Pacific Gas and Electric Company
Potter Valley Project
(FERC Docket No. P-77-331)

Re: Comments of Friends of the Eel River Concerning Eel River Flows
Under Pacific Gas and Electric Company's 2025 Flow Variance

Lake Pillsbury Water Temperature Profile - 2025

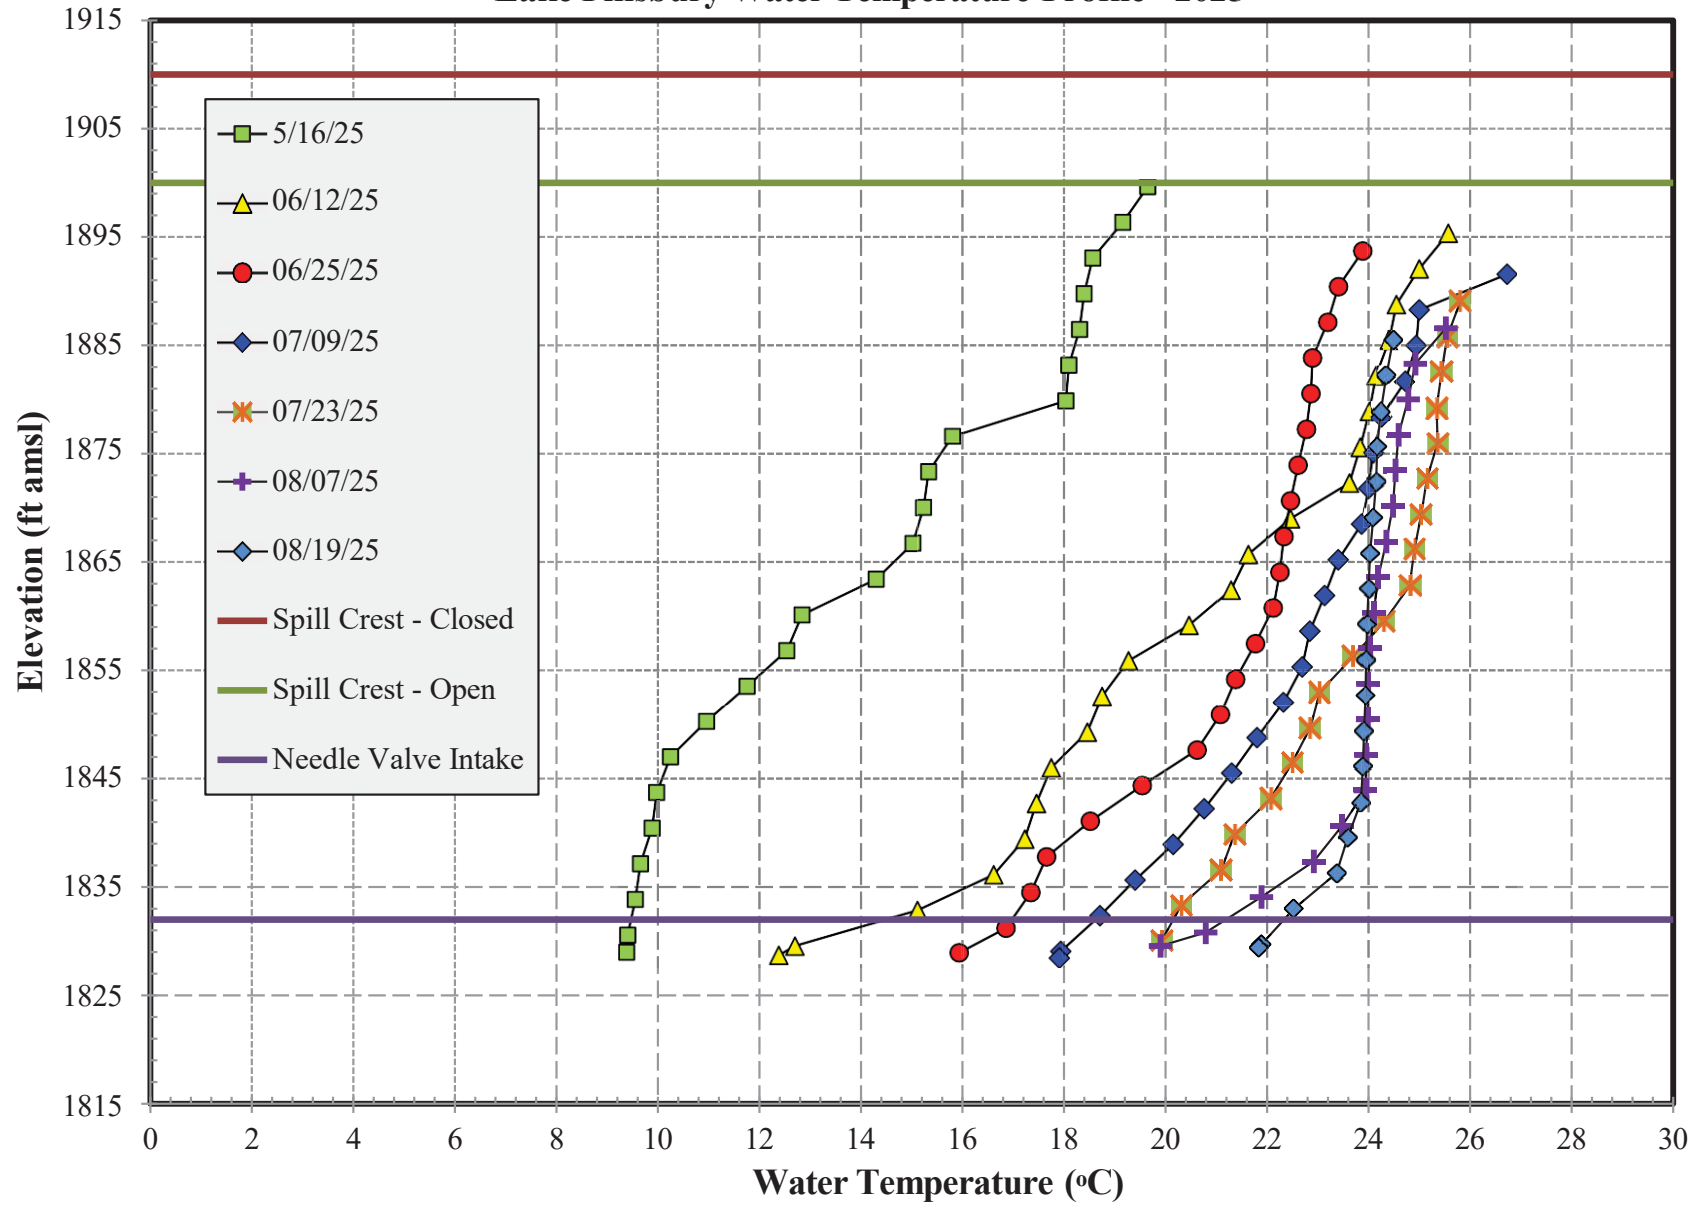
¹⁴ *Id.* at 15 (showing water in Lake Pillsbury below needle valve intake at 22°C as of August 19, 2025). Studies have shown that water temperatures below 16°C are best to protect rearing of juvenile steelhead, and that temperatures above 20°C may be directly lethal even to adult steelhead. Richter, A. and S. A. Kolmes, *Maximum Temperature Limits for Chinook, Coho, and Chum Salmon, and Steelhead Trout in the Pacific Northwest*, Reviews in Fisheries Science 123:29-49 (2005) at 35-36.

EXHIBIT

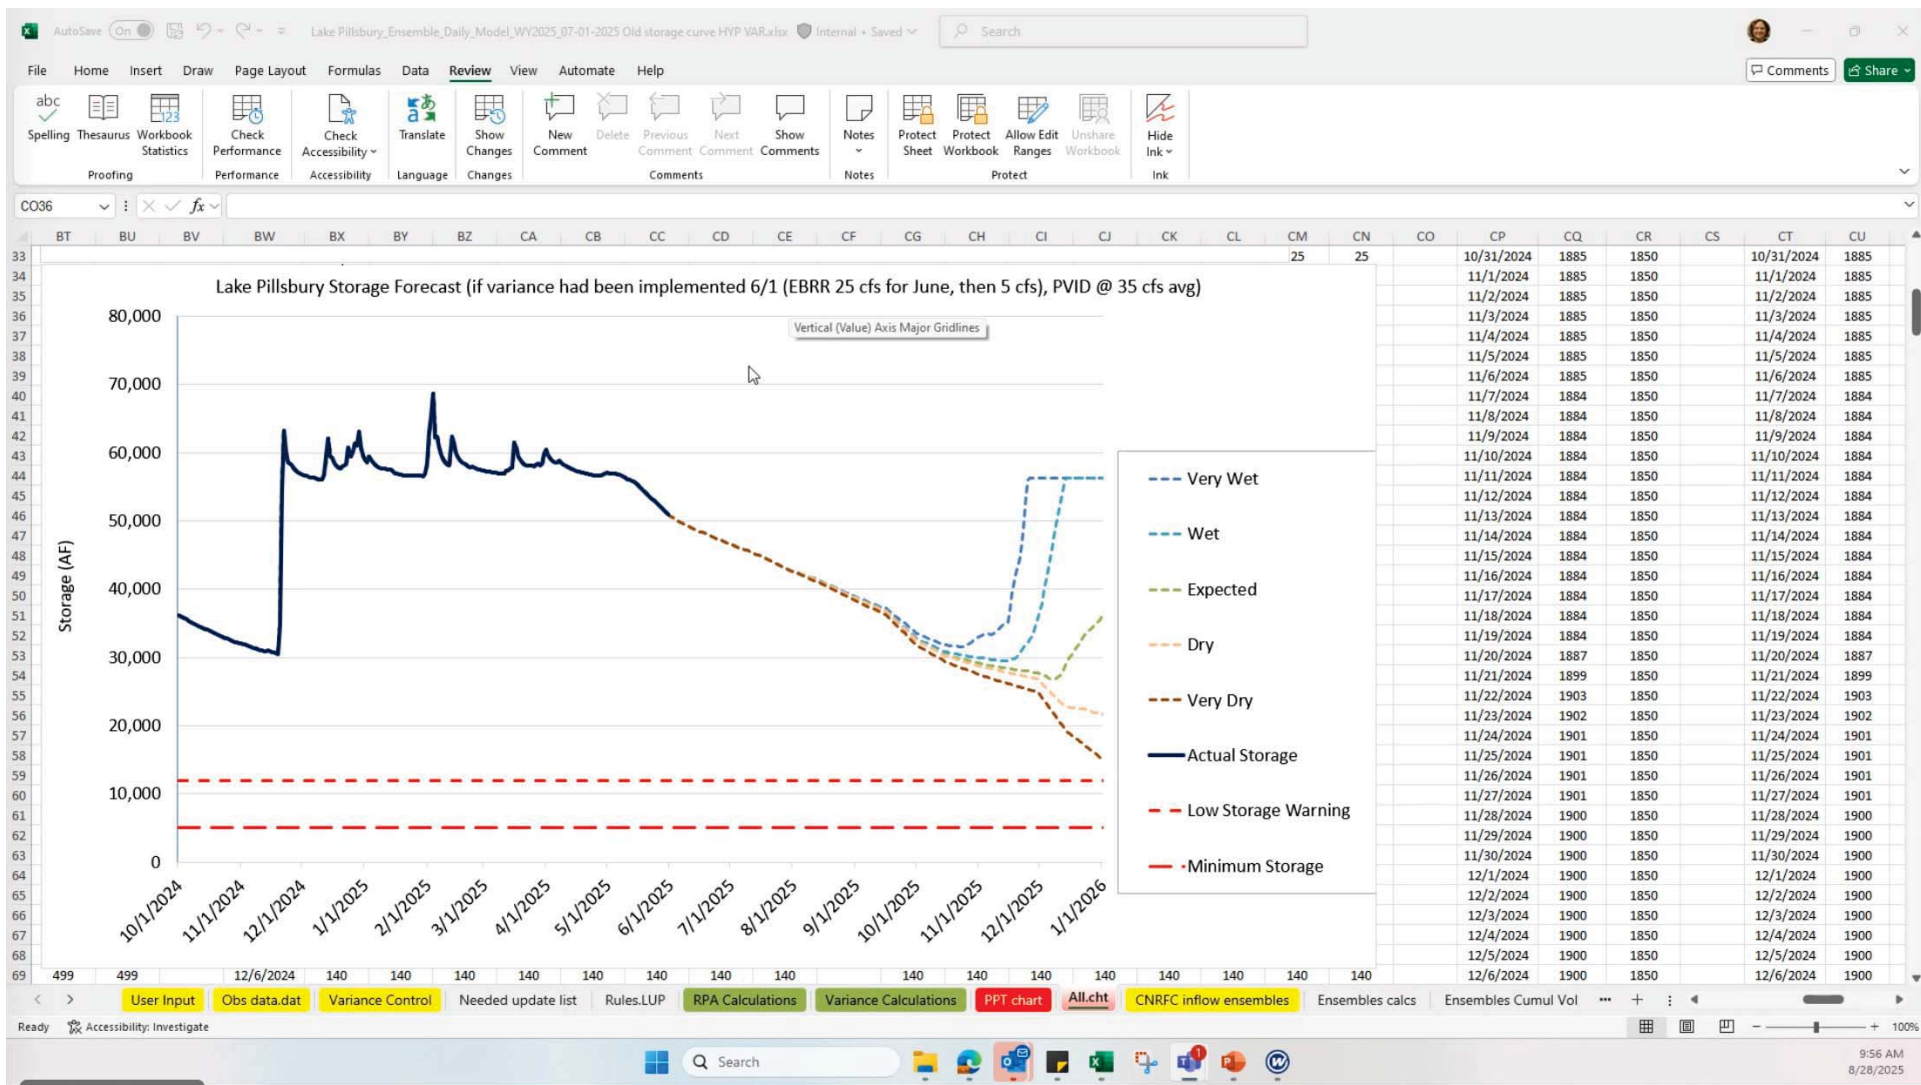
¹² Attached as Exhibit B is a screenshot of an additional slide entitled “Lake Pillsbury Storage Forecast (if variance had been implemented 6/1).” We understand PG&E presented this slide at the DWG meeting but did not include it in the main slide deck. The slide shows that if the variance had been implemented on June 1, reservoir storage would not have reached the “Low Storage Warning” stage under any precipitation scenario, even with additional deliveries to PVID averaging 35 cfs.
